**MEMORANDUM**

**To:** Mayor and City Council  
**From:** Michael Smith, Public Works Director  
**Date:** October 13, 2014  
**Subject** **4400 Ashford Dunwoody Road:** Request to waive right of way dedication requirements of Sec. 16-222

**SITE PLAN**

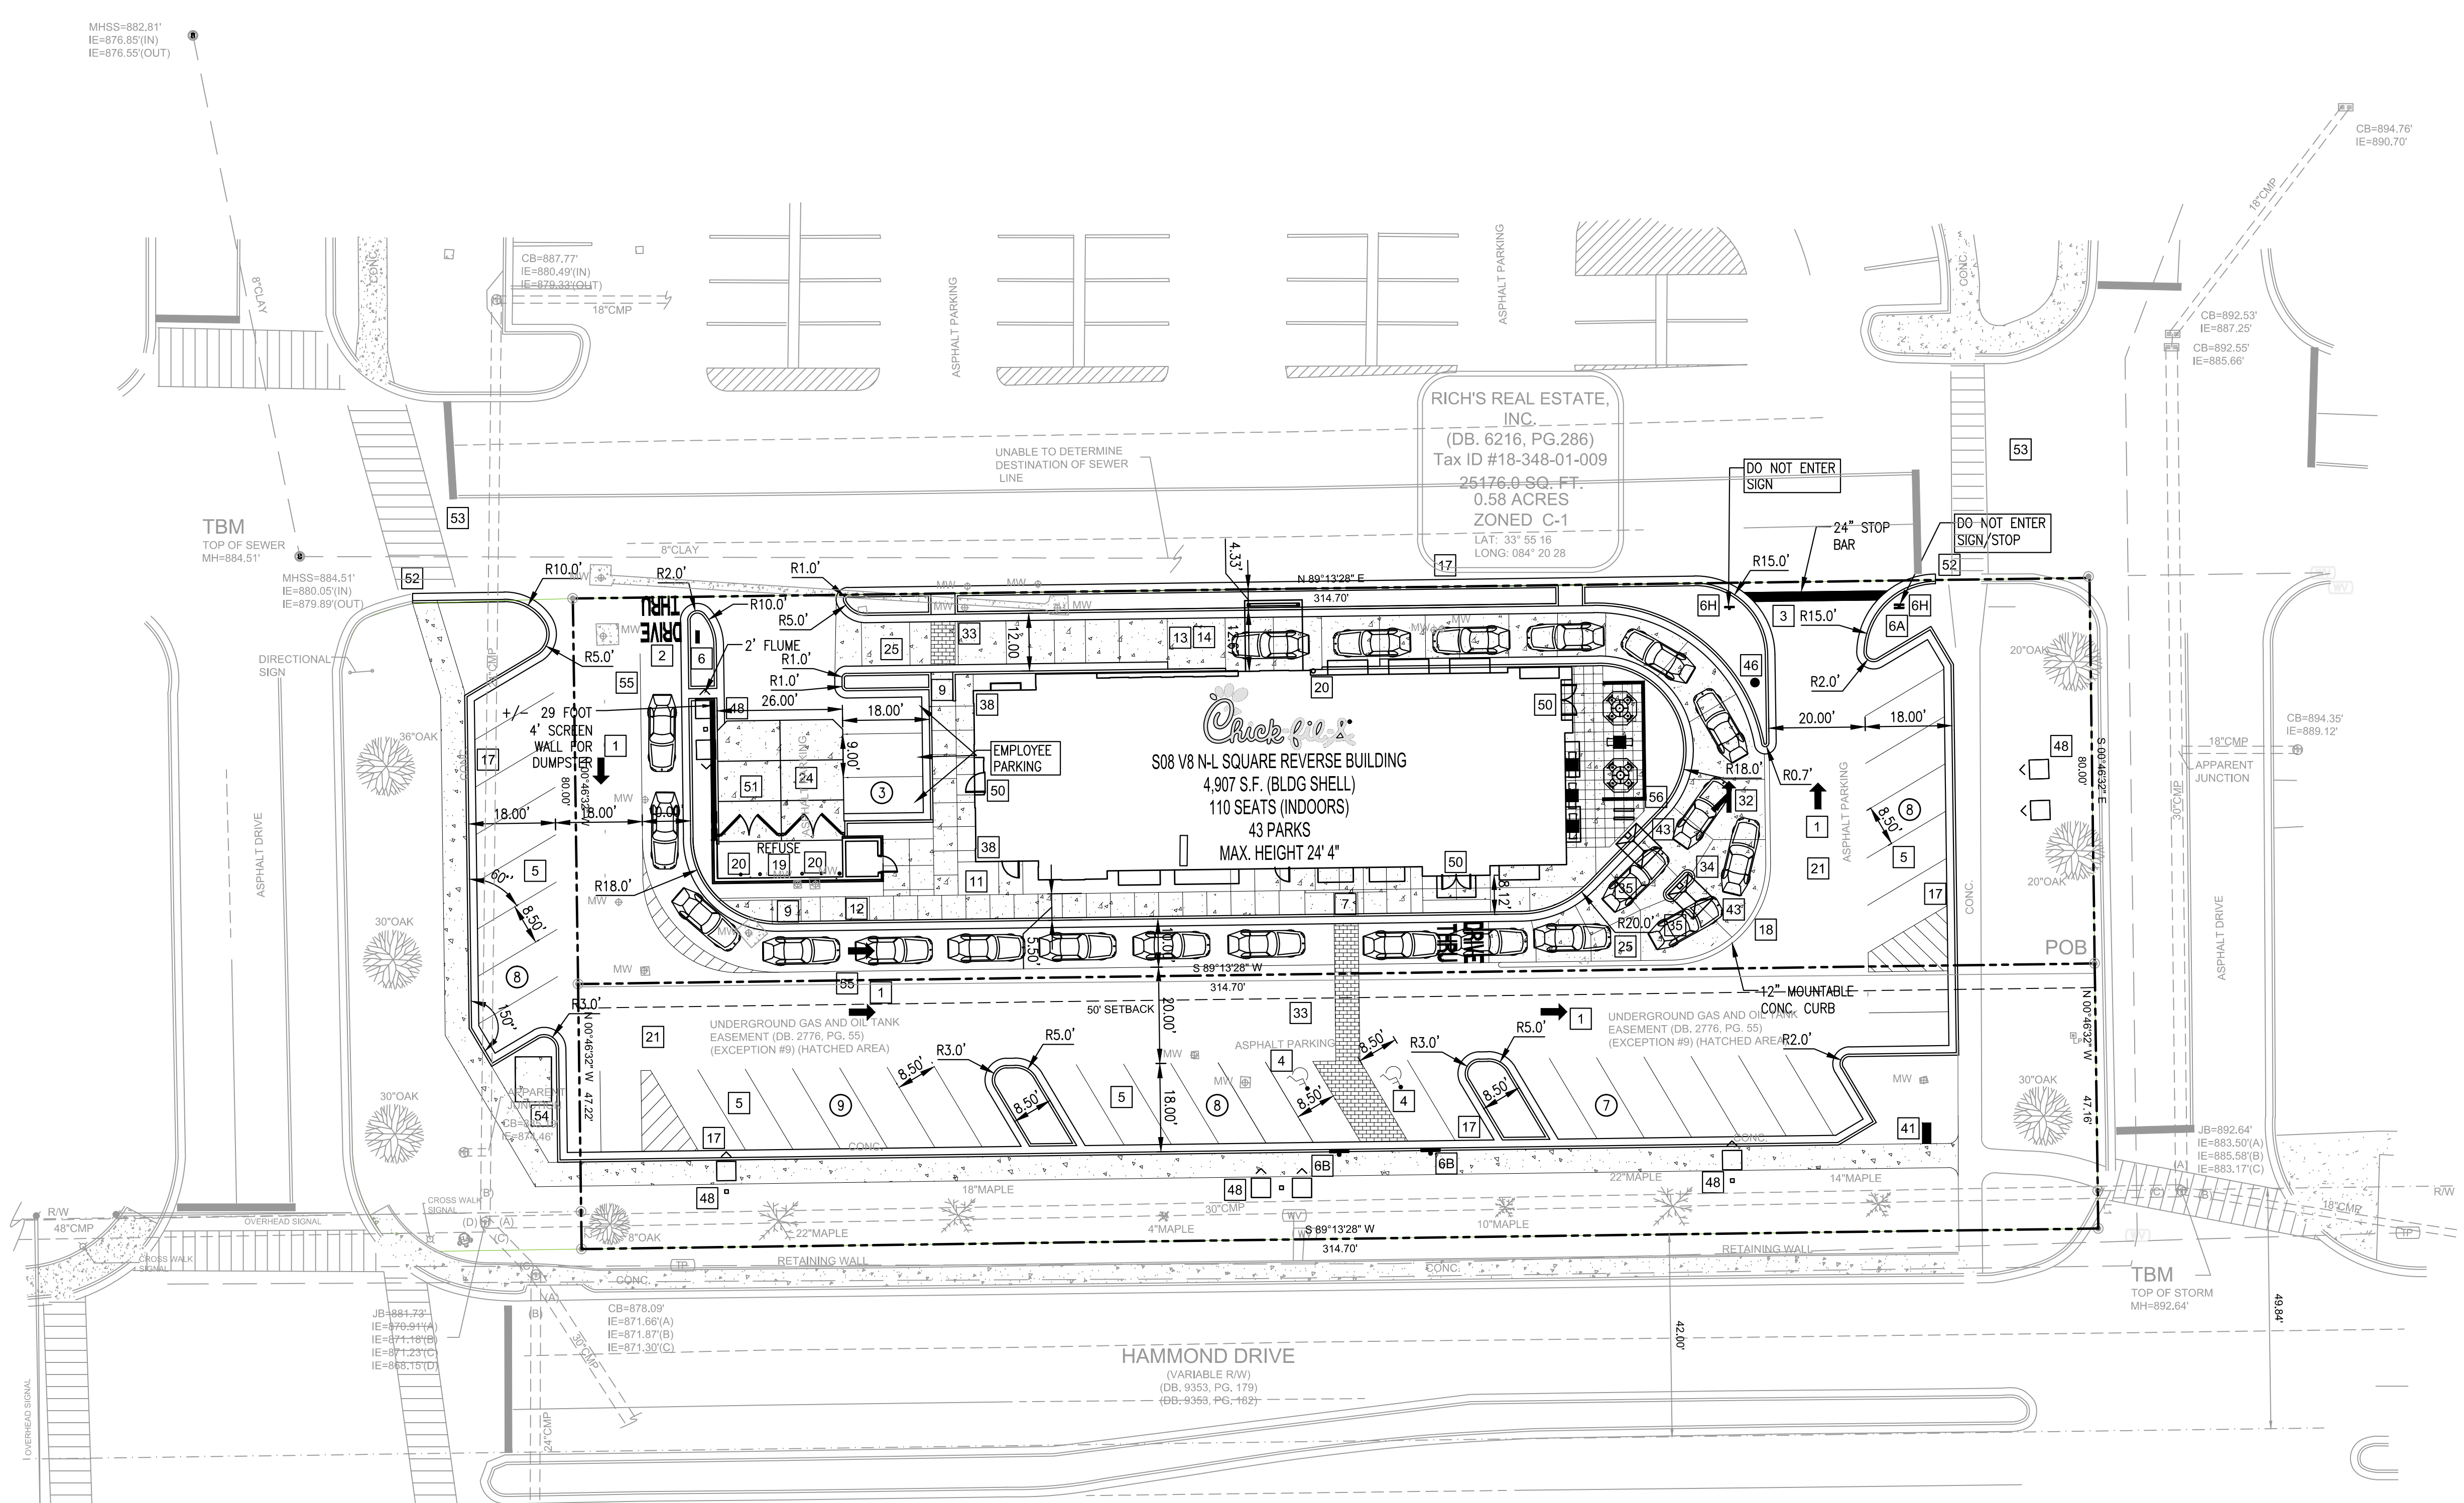
The applicant has provided a site plan that provides for a sidewalk adjacent to the parking lot with connection to the existing sidewalk along Hammond Drive at either end of the site.

At the west end of the site the connection would require steps down to the sidewalk along the street. The benefits of the proposed sidewalk location are that it would provide an ample buffer from the roadway, provide better access into the mall at the west end of the site and allow for some of the existing trees to be preserved. The primary drawback to the proposed location is that it would not be located within public right of way, and thus its continued function as a public facility could not be guaranteed.

Staff recommends approval of the applicant's request to waive the requirements for right of way dedication provided that a permanent easement can be secured for the proposed sidewalk adjacent to Hammond Drive. The easement ensures that there will continue to be a sidewalk along Hammond Drive for public use. Otherwise, the existing right of way is not sufficient for construction of a sidewalk, and the other required improvements outlined in Section 16-222(j).

**PUBLIC SPACE STANDARDS**

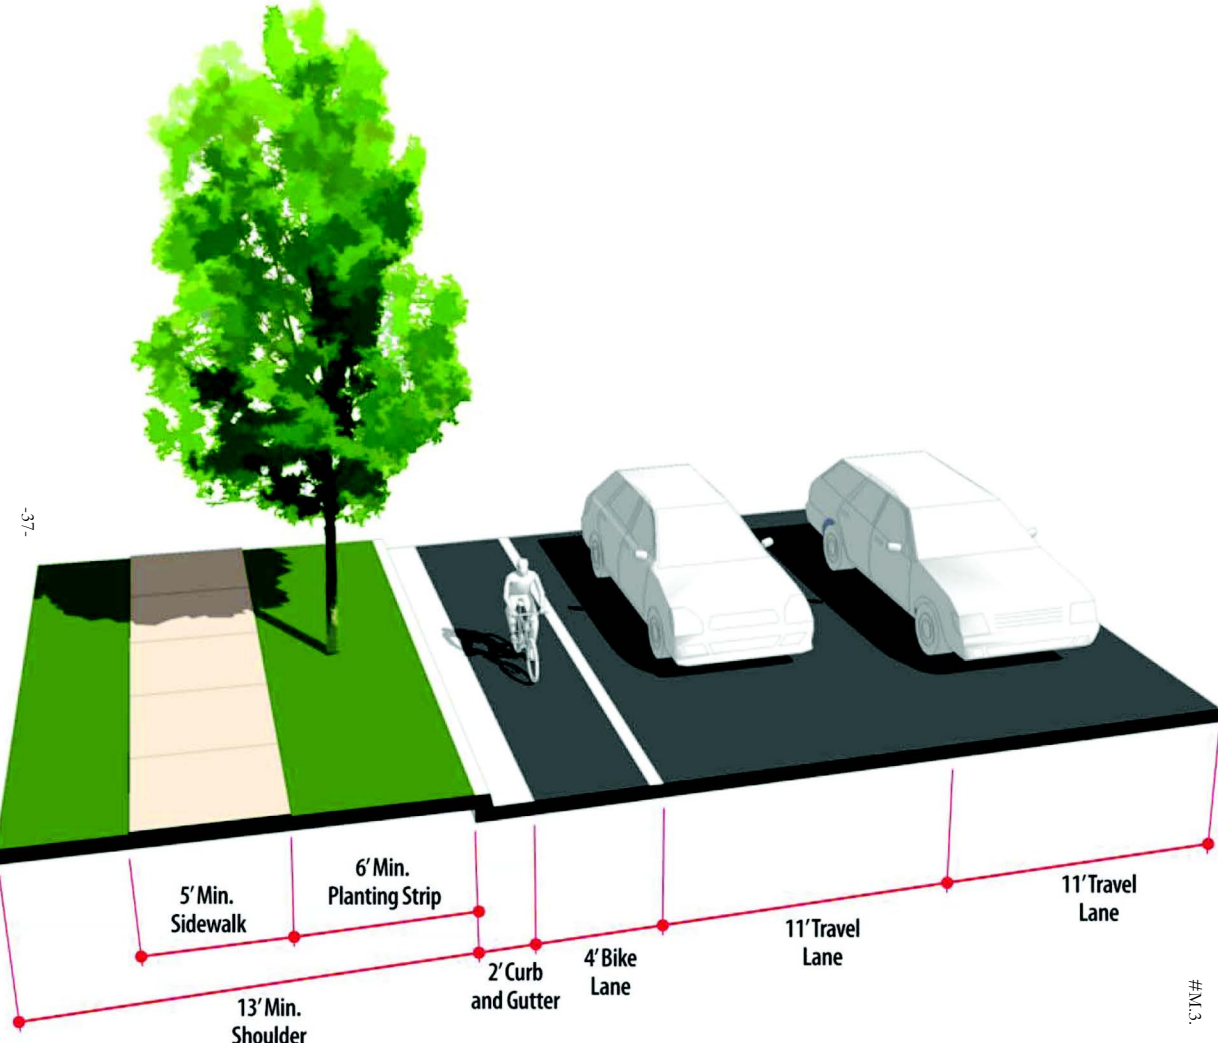
Figure 14-2 of the code (attached) provides a visual depiction of the typical street cross section that is required.

1. Perimeter Community Improvement Districts (PCIDs) Public Space Standards (figure attached)
2. Concept plans (figure attached) developed specifically for the Hammond Drive corridor by the PCIDs and referenced as a planned project in Dunwoody's Comprehensive Transportation Plan and the PCIDs Livable Communities Initiative (LCI) 2011 Update
